Staff Report

To: BOZAR
From: Jessie Earley, Town Planner III
Meeting Date: DRC, April 29, 2025
RE: 801/803 Red Lady Avenue (Ochs) Final Review

PROJECT TITLE: Ochs (801/803 Red Lady Avenue)

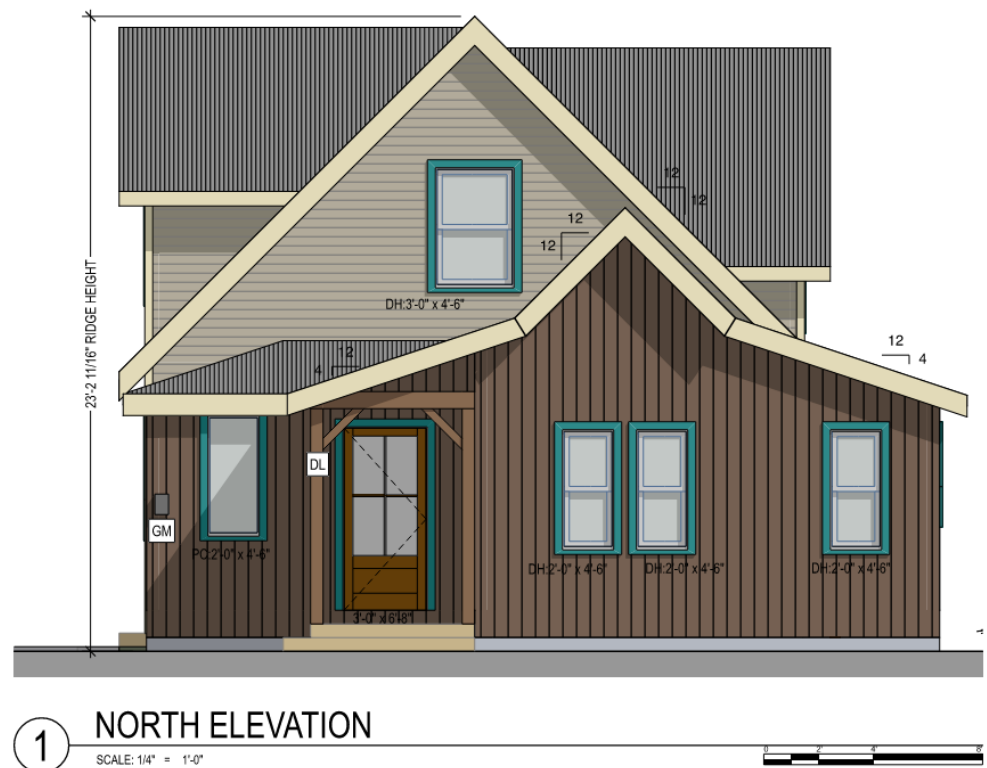
- SP1.1 Site Plan
 - Added G - grass/reseed with native grass mix
 - Greyed out for existing vs. proposed
 - Moved EM and GM together on N side under Roof.
 - Mud room window is a fixed window
 - Added Drainage Arrows towards the East.
 - Noted pavers as SAND SET PERMEABLE PAVERS
 - Added water and wastewater lines
- A 1.2-1.4 Floor Plans (Proposed)
 - Greyed out for existing vs. proposed

- Updated French door to inswing
- A 2.1 -2.3 Proposed Elevations
 - NOTED ON PLANS - ALL NEW TRIM TO MATCH EXISTING
 - All lighting to match existing, down casting light. Attached Photo.
 - Vertical siding to be medium brown wood plank, durable, sustainable, Class A fire rated 1x4 IPE wood siding.
 - Separated 3 windows by 3 inches-Divided light. Windows are same size as small square at base of stairs.
 - New posts to be medium brown 5 x 5.

Proposed Site Plan

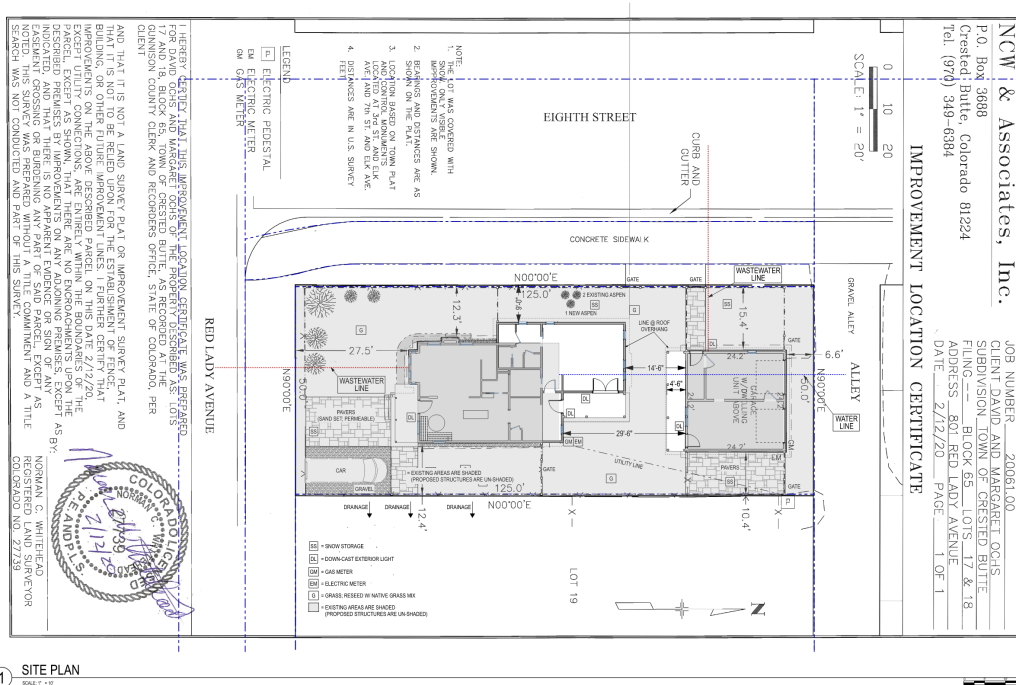
2.8 Drainage	Drainage information has been provided. Drainage arrows have been shown and notes drainage to the east. A swale may be required, as drainage cannot be placed onto adjacent properties.	Add information to plans.
Easements	NA	NA

2.19 New trees	There is one new aspen tree proposed for the west. Support.	Support
2.16 a./ 2.20 Native plantings	Ground cover is noted for disturbed areas as native grass mix, which is encouraged to be native grasses by the GL.	Add information to plans

2.16 e Pervious materials 2.28 e & f Parking substrate	Pavers are noted on the south for the parking and north for snow storage area and then a small walkway on the west elevation for the ADU. These pavers are called out as sand set pavers and are existing.	Add information to plans

Solar 2.10	NA	NA
Utilities	<p>Utility lines have been shown for dry utilities. Meters were moved to both be under the north roof.</p> <p>Water and wastewater lines have now also been shown.</p> <p>Adjacent rights of way have been included to scale Ruth's Road.</p>	Add information to plans
2.7 Snow Storage	Snow storage has been provided onsite and meets the 33% requirement of the areas to be plowed.	Support
2.25 Fences	There is an existing fence noted on the existing site plan. This will be revised based upon the addition and is shown on the proposed site plan.	Support

4/29 BOZAR: Revised Proposed – North

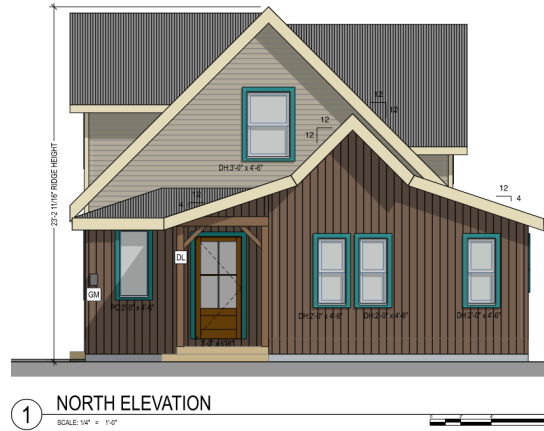
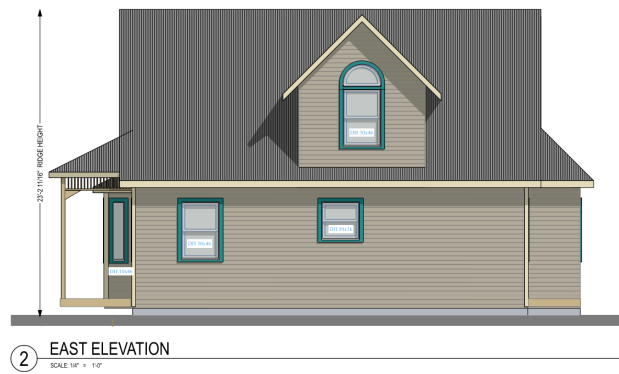
4.42 Shed roofs	There are two shed pitch breaks (4:12) on either side of the 12:12 roof, which appears a bit atypical.	3/17 DRC: Members were concerned regarding the proposed pitch break on either side, as this is not a detail often seen in town. They suggested carrying this down to the ground. The applicant has provided a break in the fascia.

4.43 Mix styles	The mix of small gable with shed pitch breaks appears a bit atypical.	3/17 DRC: Members were concerned regarding the proposed pitch break on either side, as this is not a detail often seen in town. They suggested carrying this down to the ground. The applicant has provided a break in the fascia.

North: Members suggested continuing fascia/trim/corner boards to give the illusion of the gable. As proposed, the roof forms are compliant as pitches are concerned, but the forms are not something seen within town.

4/29 BOZAR: Revised Proposed East

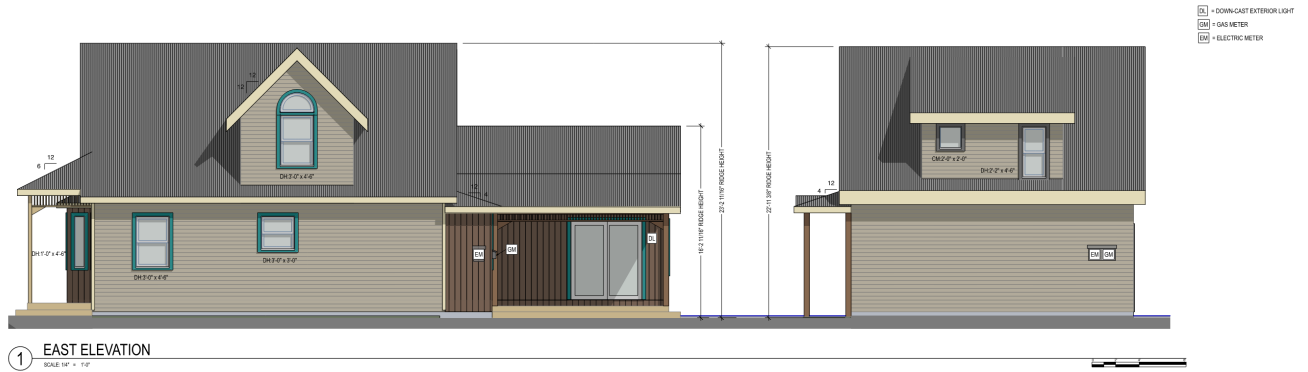
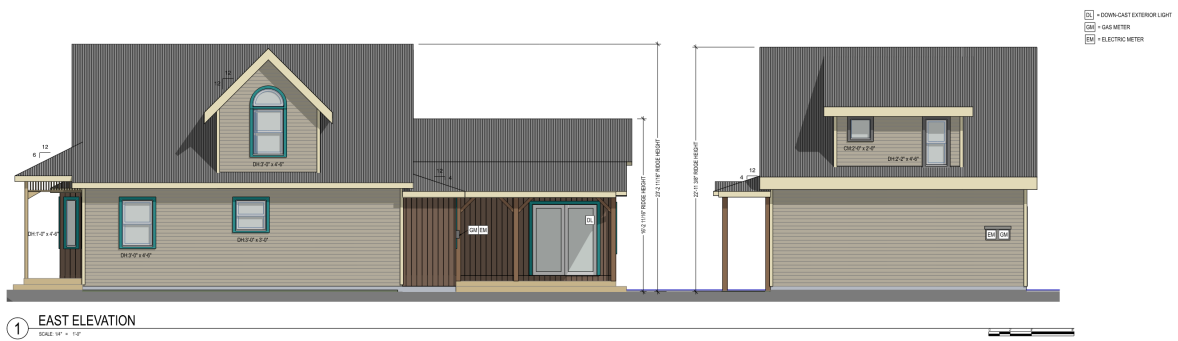
There is another door on the east elevation, which must be confirmed for type and material. It appears that the door might be a sliding glass door.

East elevation: support with discussion about the door, as proposed. Sliding doors aren't supported by GL 4.66 a. Schmidt mentioned they could erect a wall on the east side of the porch and keep the sliding glass door, which would then be interior. If it is exterior, it would need to be a French or bifold.

4/29 BOZAR: Revised proposed west elevation

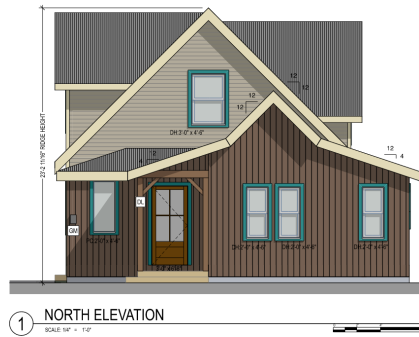
<p>casement, with simulated divided lights which is consistent with historic homes.</p> <p>There is one window on the north, which is proposed as a full light window, which must incorporate divided lights.</p> <p>The windows are proposed as double hung and, casement (egress), which is supported by GL 4.54 a with the notation of simulated divided light. Window operations are noted on the plans and a window schedule should be included.</p> <p>Per GL 4.54 c, the windows on the west elevation must include divided lights.</p>

4.58 Groupings of 2 or more windows	The three pack of square windows on the west, appears to conflict with GL 4.58, as they will be highly visible from Eighth Street. The windows must be separated by siding to be single windows. The applicant provided 3" of trim, but the window still appears as though it may conflict with this GL.	3/17 DRC: Members asked for this three pack to be revised. The applicant has provided for increased trim.

West: the three pack of windows was discussed. They will include divided lights and also, have 3.5" trim between. This trim will be turquoise to match other trim details.

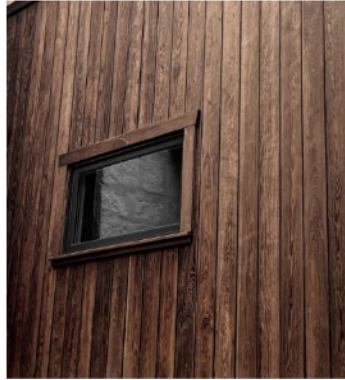
GL	Staff Analysis	DRC Recommendation
2.37 /4.74 Exterior lighting	<p>Exterior lighting has been called out as down lighting. Any existing exterior fixtures must be replaced if they do not meet current standards as well. An example of the fixture has been provided:</p>

East Elevation – ADU

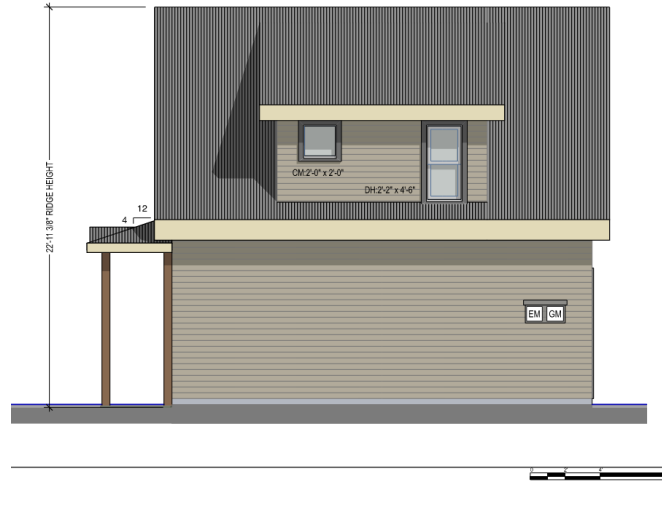
GL	Staff Analysis	DRC Recommendation
4.49 Covered porches	The new porch, as proposed, is simpler than the primary building. Support.	Support
4.50 Mix of styles	NA	NA
4.51 Side or rear porches	NA	NA

There will be new posts, sizing must be confirmed (medium/dark brown).
